2023 Sewer Main Replacement Project 3  
Solicitation Number: CO-00724  
Job No.: 23-4519

**ADDENDUM 1**  
**April 16, 2024**

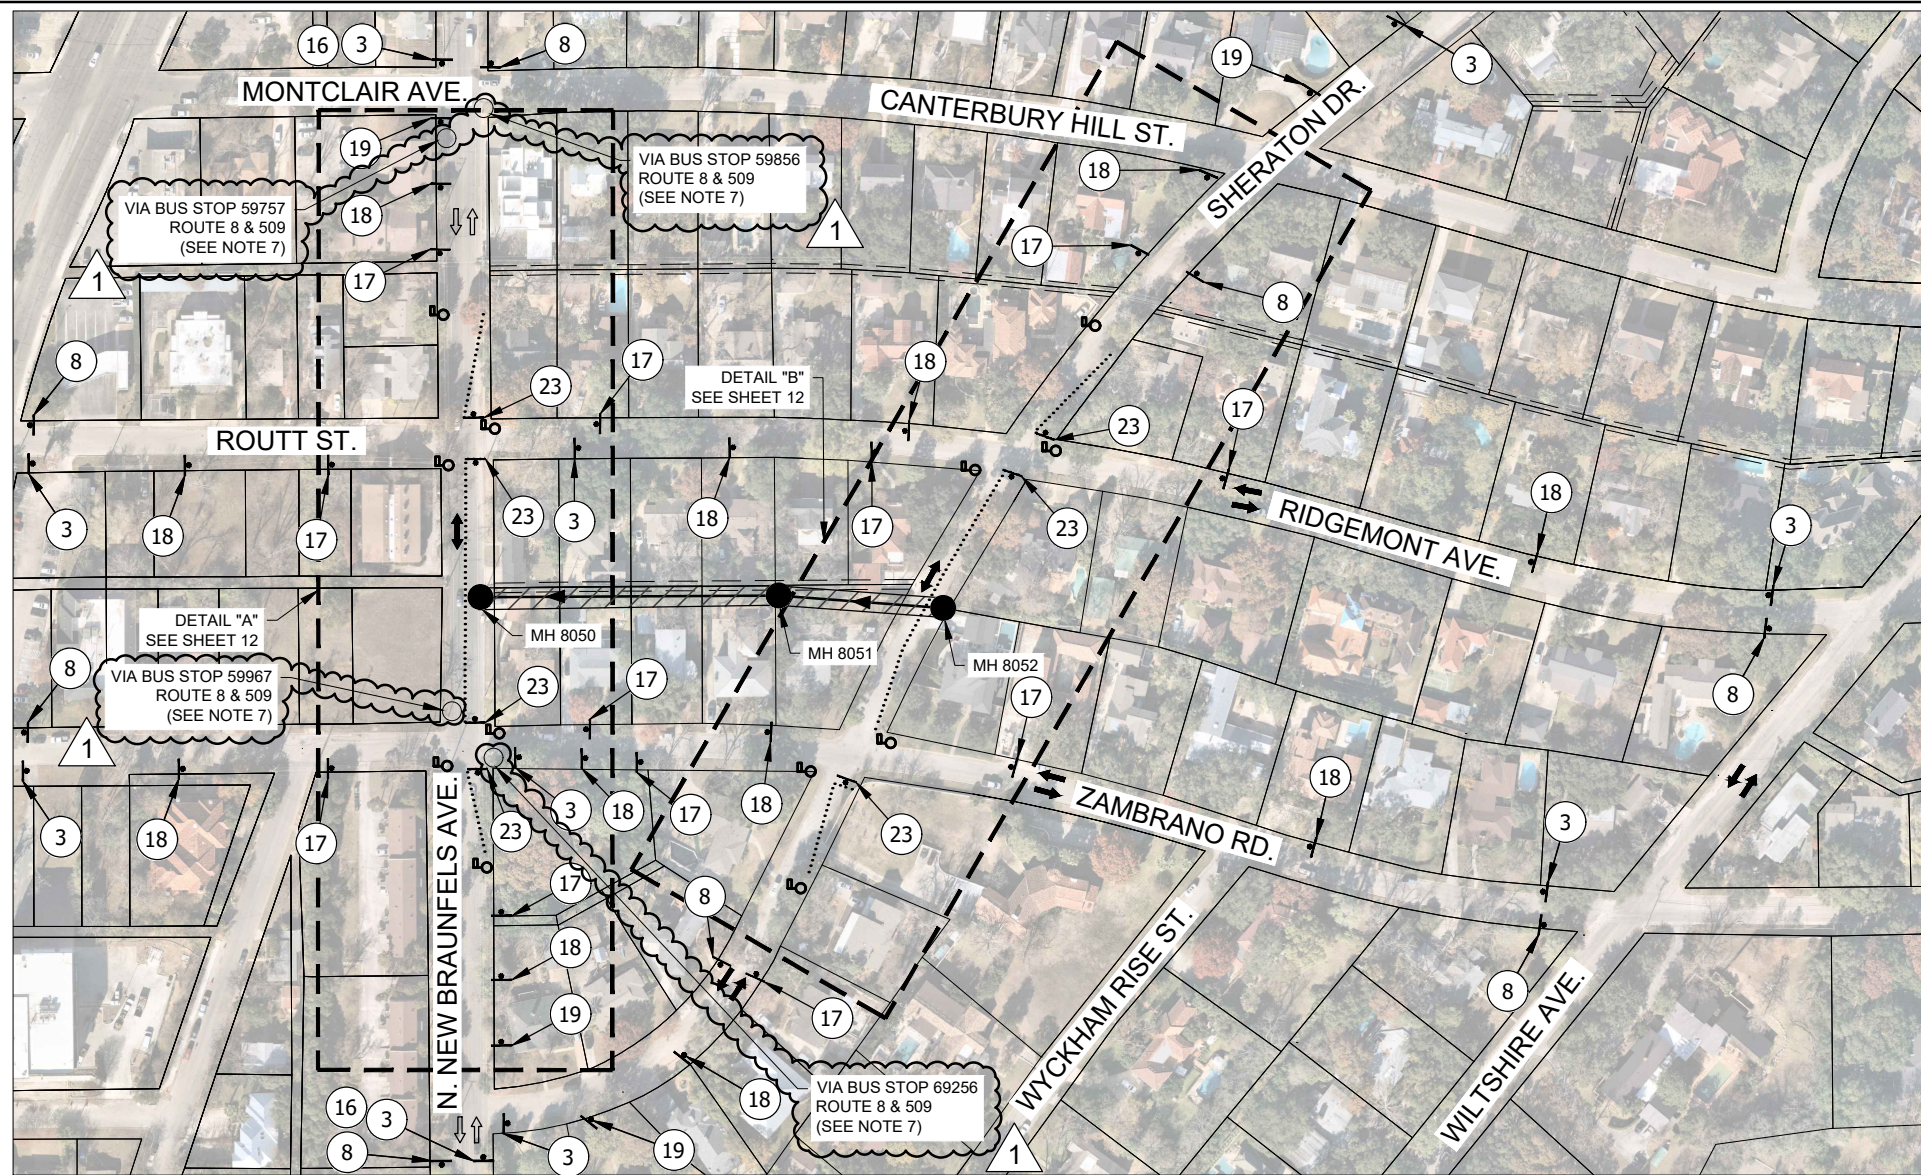
1. Remove the following and replace with the attached sheets.
  - General Notes (1 of 2) – Sheet 3
    - Updated VIA Bus Notes
  - Summary of Quantities – Sheet 5
    - Updated the Line Item 1109.4 to 31

2023 SEWER MAIN REPLACEMENT PROJECT 3  
 SITE A - COMPEKEY 969666 & 968957,  
 TRAFFIC CONTROL PLAN 1 OF 2,  
 SANITARY SEWER REHABILITATION

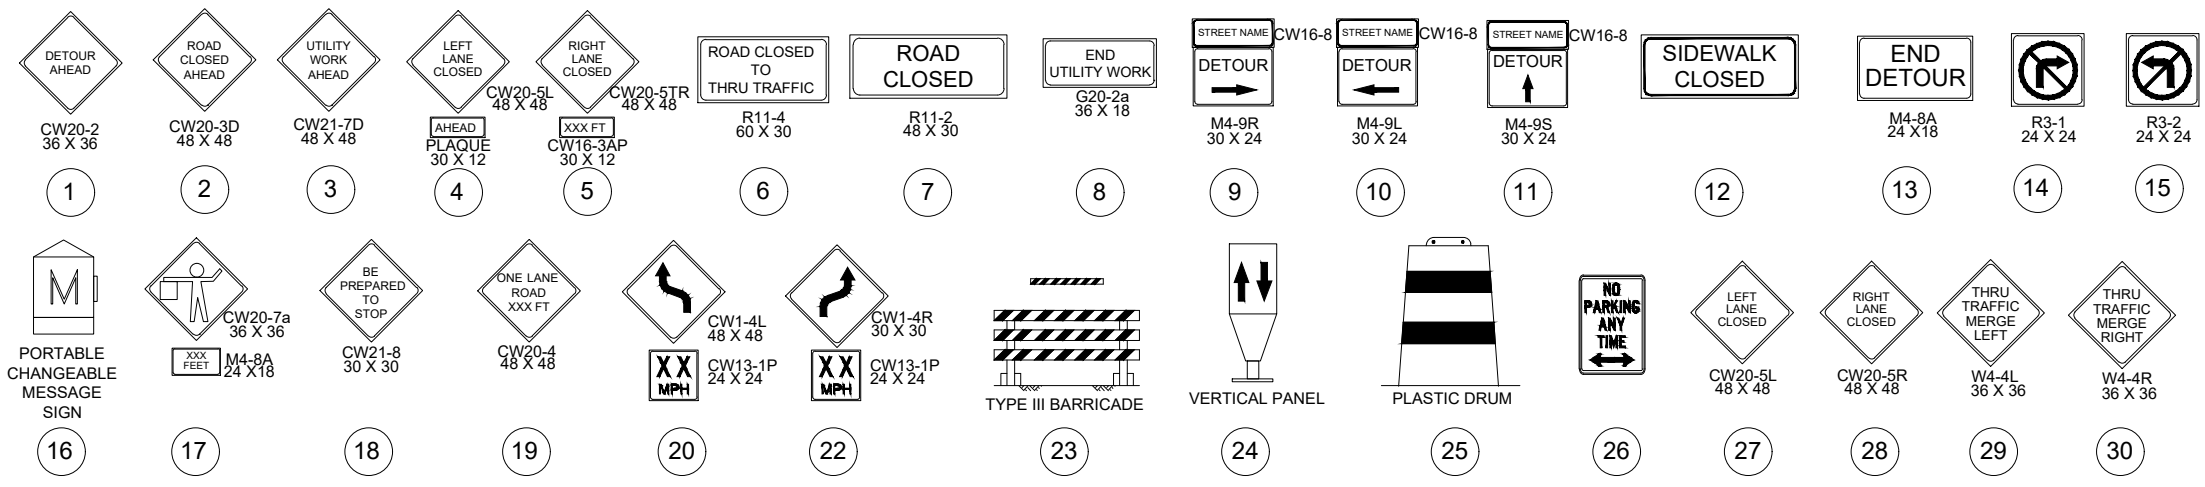
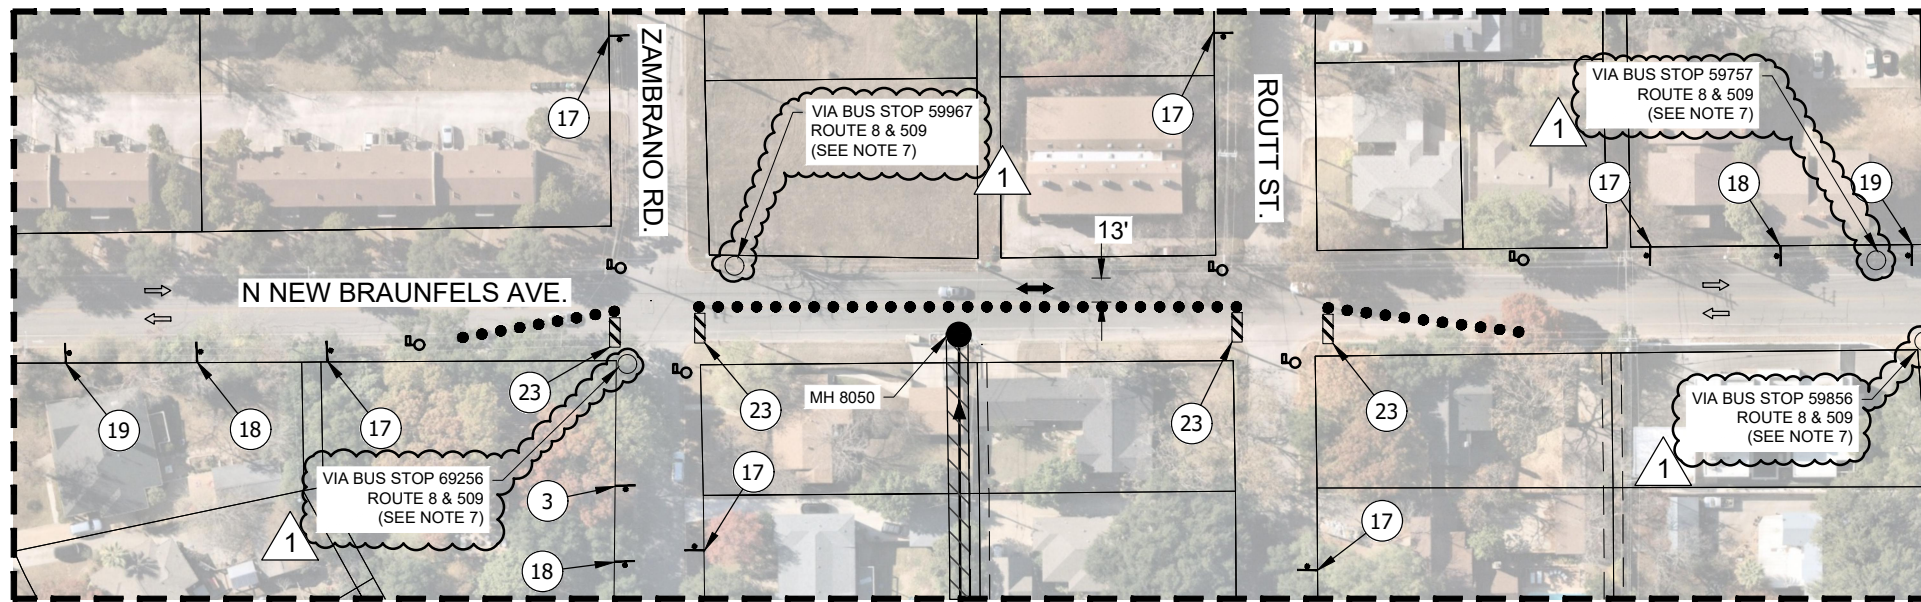
- Site A – Compkey 969666 & 968957, Traffic Control Plan 1 of 2, Sanitary Sewer Rehabilitation – Sheet 11
  - Added VIA Bus Stop Locations and a note to reference VIA Bus Notes in General Notes

7. CONTRACTOR SHALL REFERENCE SHEET 3 VIA BUS NOTES FOR ADDITIONAL INFORMATION.

2023 SEWER MAIN REPLACEMENT PROJECT 3  
 SITE A - COMPEKEY 969666 & 968957,  
 TRAFFIC CONTROL PLAN 2 OF 2,  
 SANITARY SEWER REHABILITATION

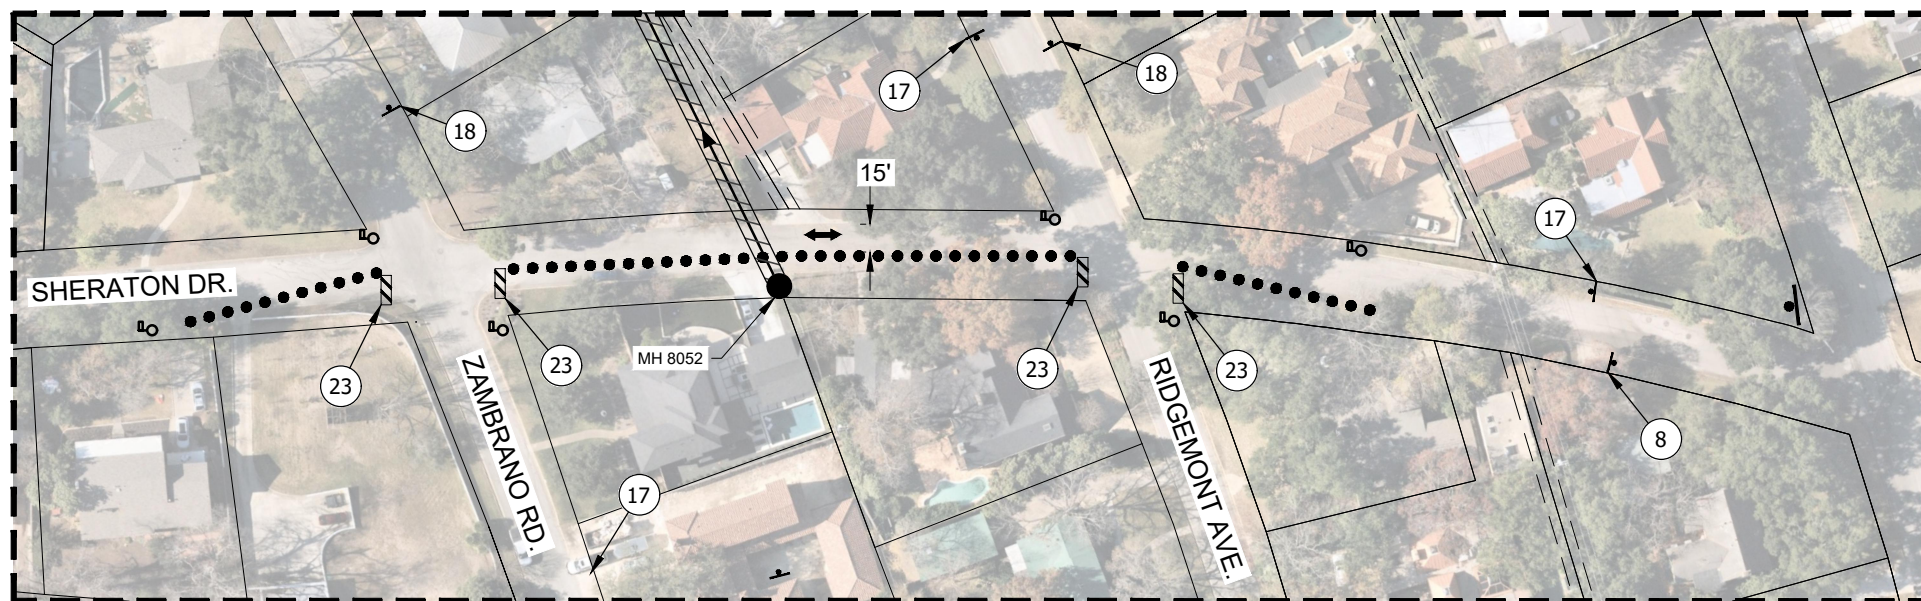
- Site A – Compkey 969666 & 968957, Traffic Control Plan 2 of 2, Sanitary Sewer Rehabilitation – Sheet 12
  - Added VIA Bus Stop Locations and a note to reference VIA Bus Notes in General Notes

7. CONTRACTOR SHALL REFERENCE SHEET 3 VIA BUS NOTES FOR ADDITIONAL INFORMATION.

SITE D - COMPKEYS 980185, 971037, 970260, 3524688 & 969745, TRAFFIC CONTROL PLAN, SANITARY SEWER REHABILITATION

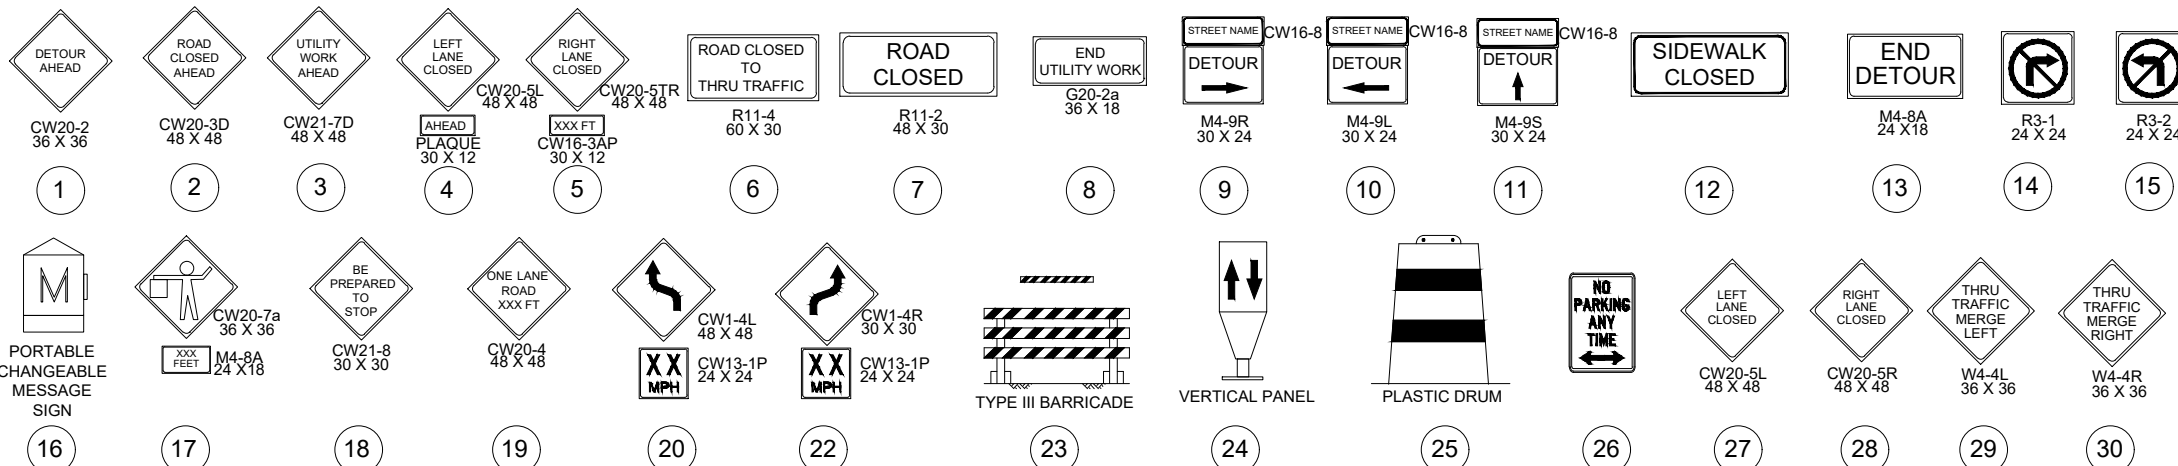
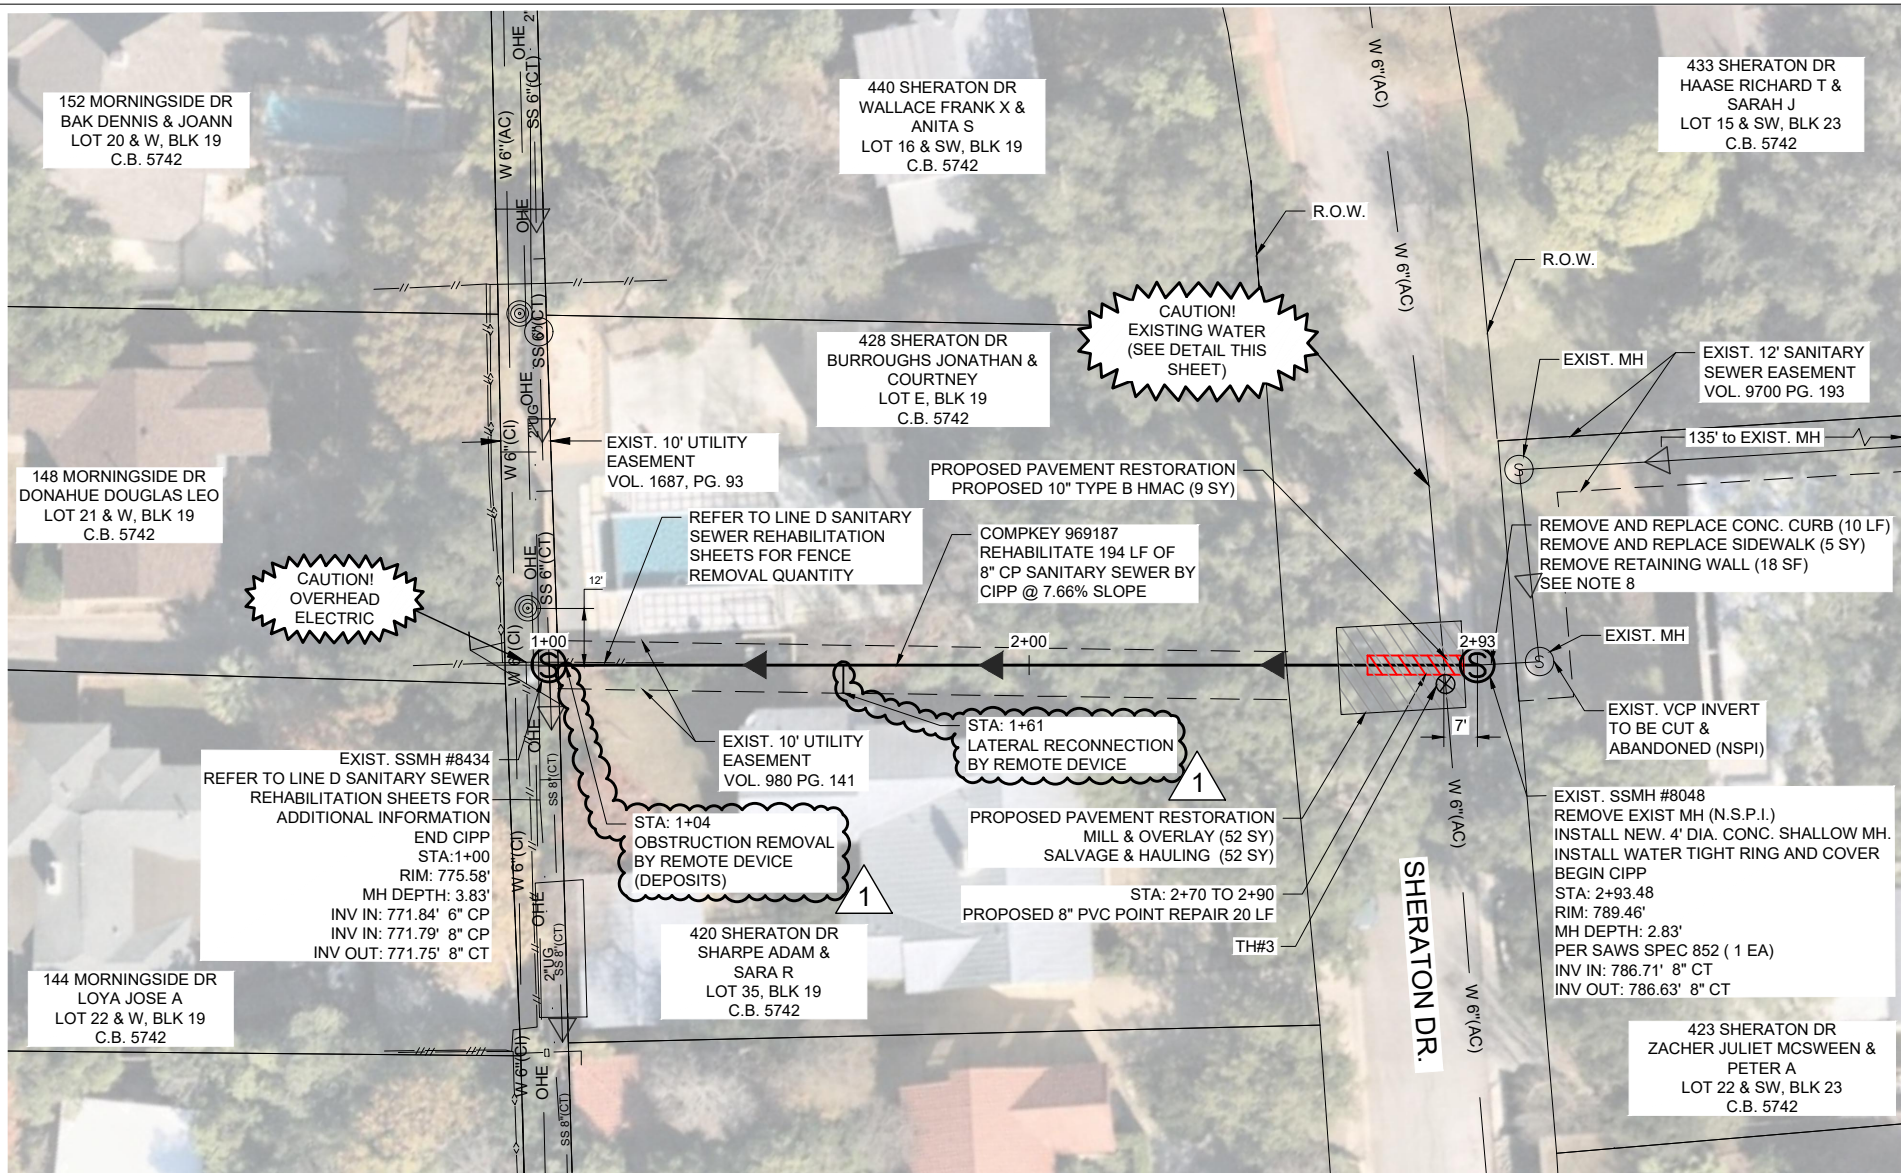
- Site D – Compkey 980158, 971037, 970260, 3524688 & 969745, Traffic Control Plan, Sanitary Sewer Rehabilitation – Sheet 17
  - Added VIA Bus Stop Locations and a note to reference VIA Bus Notes in General Notes

7. CONTRACTOR SHALL REFERENCE SHEET 3 VIA BUS NOTES FOR ADDITIONAL INFORMATION.

2023 SEWER MAIN REPLACEMENT  
PROJECT 3  
SITE NO. 5  
CONCEPTUAL TRAFFIC CONTROL PLAN  
BUENA VISTA ST

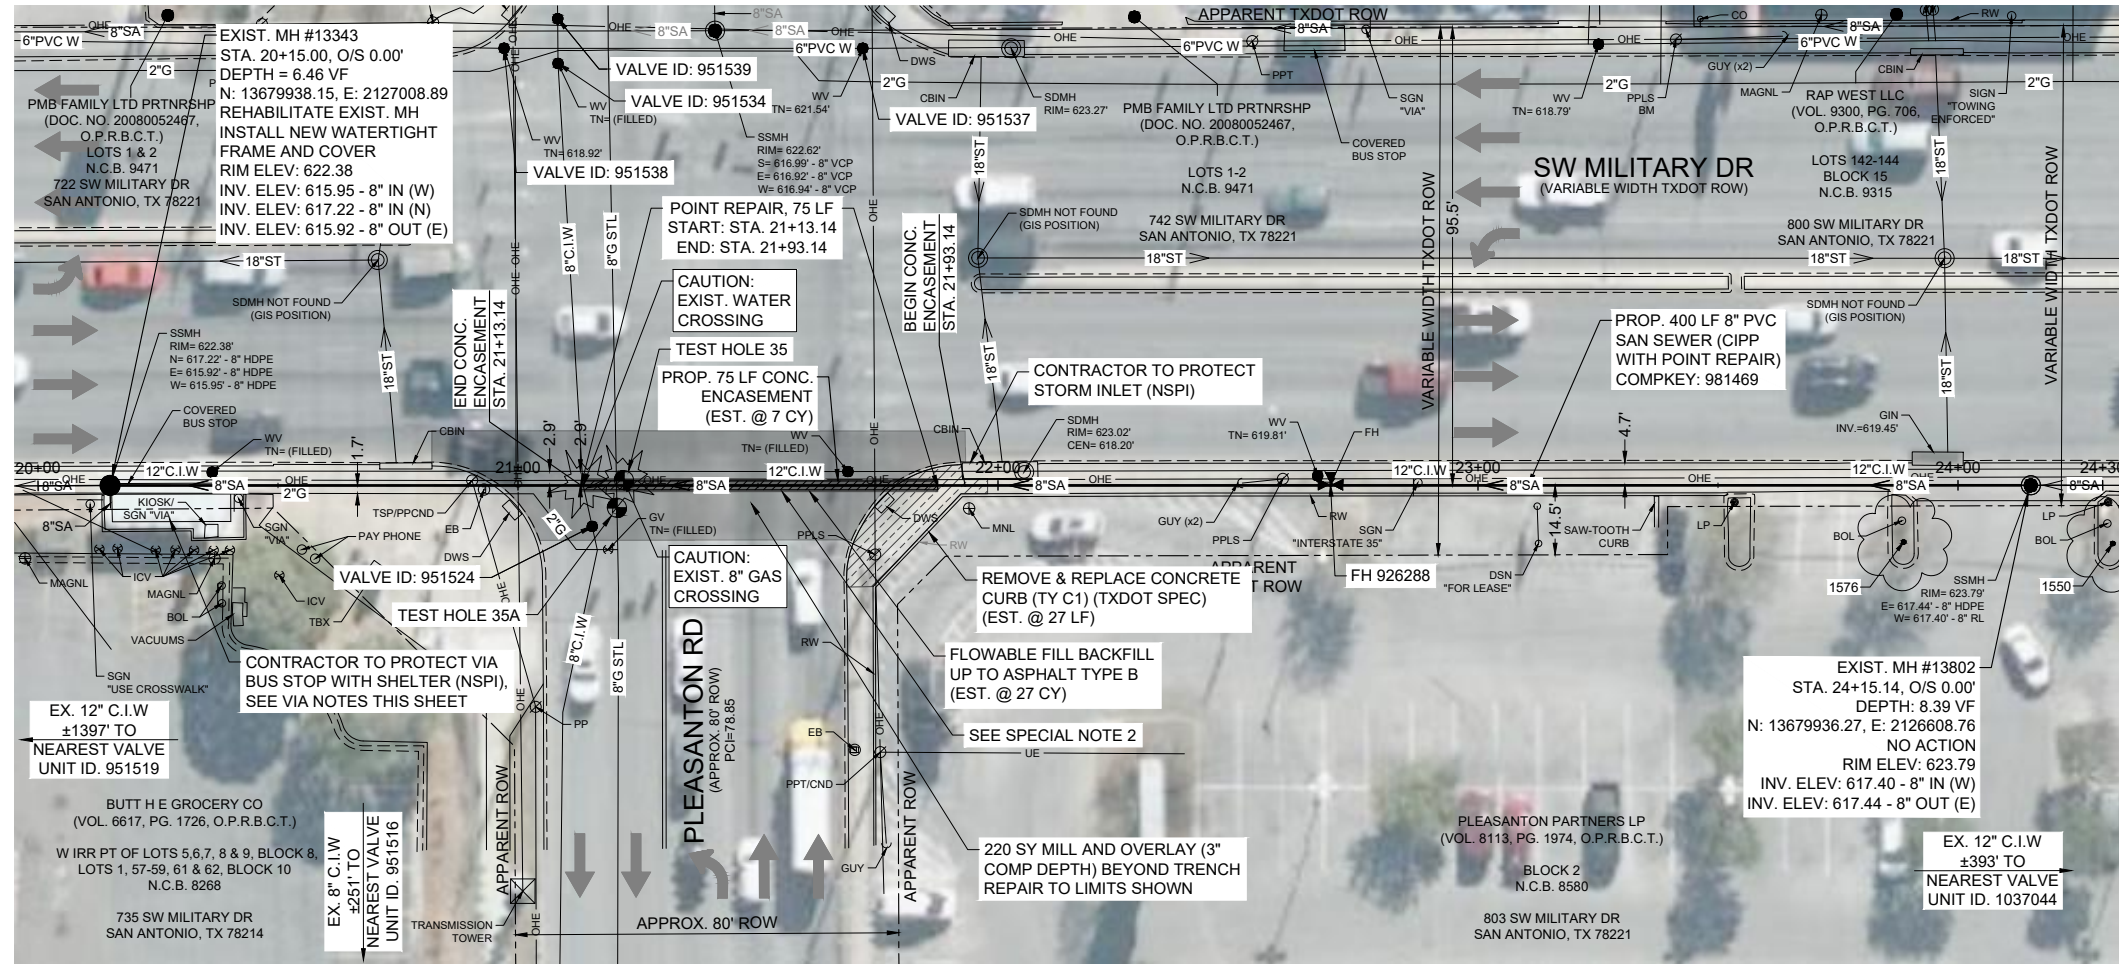
- Site No. 5 – Conceptual Traffic Control Plan Buena Vista St – Sheet 30
  - Updated VIA Notes
- Site No. 33 – Compkey 981469 SW Military Dr CIPP Plan – Sheet 31
